COMMONWEALTH OF KENTUCKY
BEFORE THE PUBLIC SERVICE COMMISSION

Application of Kentucky Power Company for Approval of)
its Environmental Compliance Plan, Approval of its Amended) CASE NO. 2011-00401
Environmental Cost Recovery Surcharge Tariffs, and for the)
Grant of Certificates of Public Convenience and Necessity)
for the Construction and Acquisition of Related Facilities)

NOTICE OF ERRATA TO DR. JEREMY FISHER'S DIRECT TESTIMONY
(PUBLIC AND CONFIDENTIAL) AND JAMES RICHARD HORNBY'S
DIRECT TESTIMONY (PUBLIC VERSION)

15 **Figure 1. Cumulative present worth (CPW) of Options 1 (retrofit), 2 (NGCC replace in**
 16 **2016), and 4A (market purchase to 2020) under Company Base assumptions (left) and**
 17 **Synapse revised assumptions and corrections (right). See text for details.**

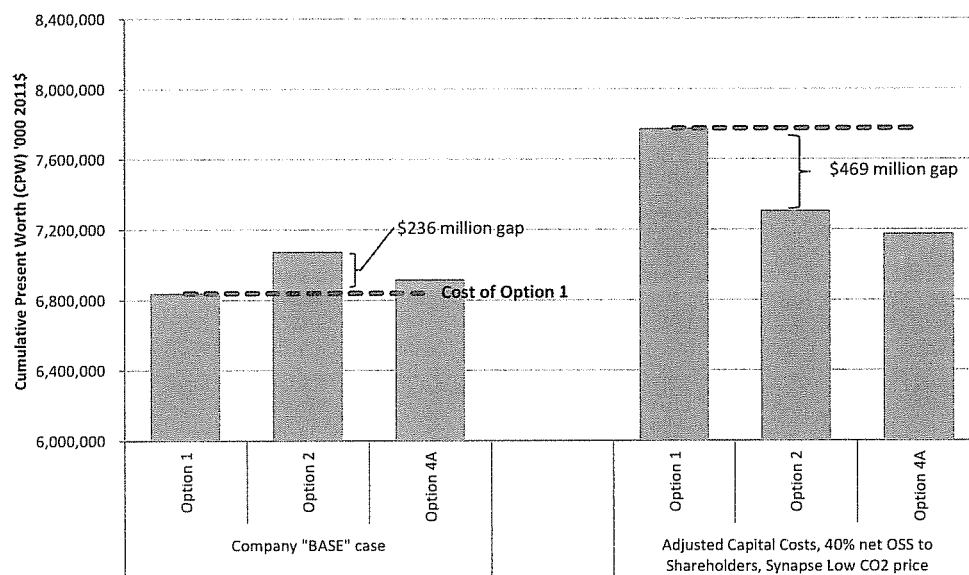
- Page 11 line 7. Replace "Exhibit JIF-2" with "Exhibit JIF-S2"
- Page 11. Replace Figure 1 with a revised Figure 1.

7 **Figure 1** below (also **Exhibit JIF-S2**) shows the total cumulative present worth
 8 (CPW) of Options 1, 2, & 4A under the Company’s “BASE” assumptions on the
 9 left, and the gap that appears to render Option 1 least cost of these three options.
 10 On the right, I show the results of our analysis after correcting the Company’s
 11 capital carrying costs, an allocation of off system sales (OSS) to shareholders, and
 12 running the model under a low-bound carbon dioxide cost (CO₂) representative of
 13 that used by other utilities and organizations.

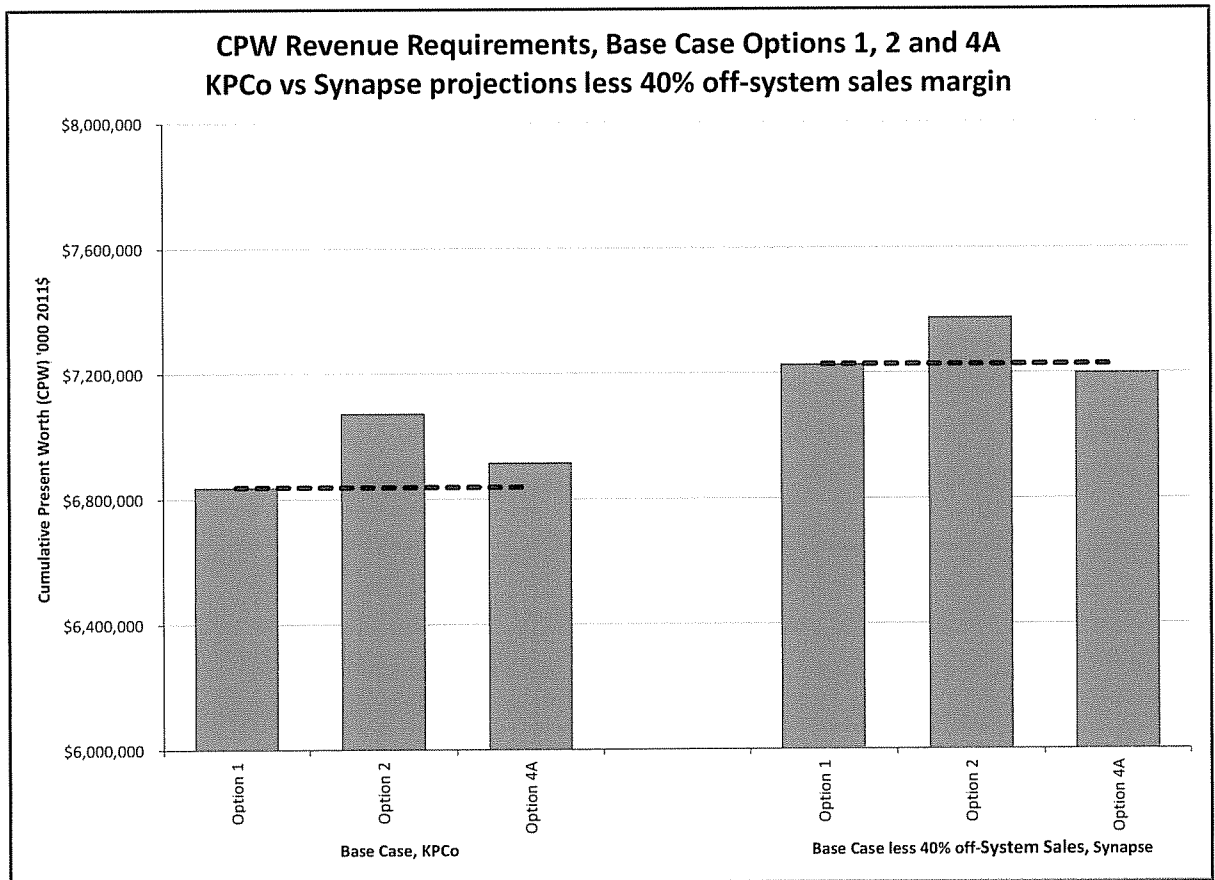
- Page 18 line 17. Add “revised” after Exhibit___(JRH-7)
- Page 19. Replace bar chart with revised bar chart.

If the Company’s projection of revenue requirements reflected a continuation of the current System Sales Clause, and credited only 60% of the margin from off-system sales against gross revenue requirements, the difference in CPW between Option 1 and the other three Options is reduced substantially. Dr. Fisher quantifies that impact, which is illustrated in the bar chart from Exhibit ___(JRH-7) revised.
